**Technical Service
BULLETIN**

Title:
**TRAILER WIRE HARNESS
INSTALLATION NOTE**

Models:
'98 Land Cruiser

AX002-98
ACCESSORIES

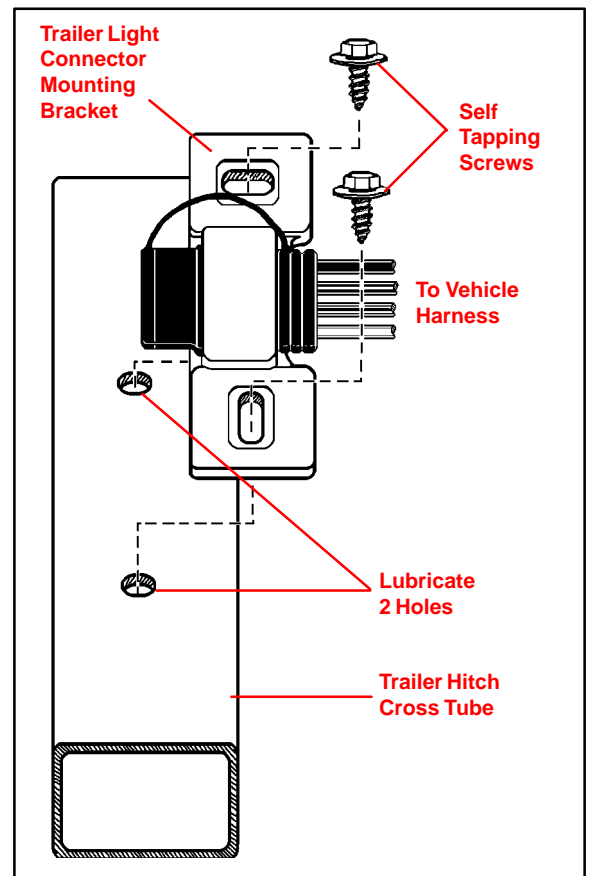
Introduction The self tapping screws, placed in the trailer hitch cross tube to attach the wire harness bracket, require lubricant to prevent breaking during installation.

Spray lubricant in cross tube holes and then install mounting bracket with self-tapping screws.
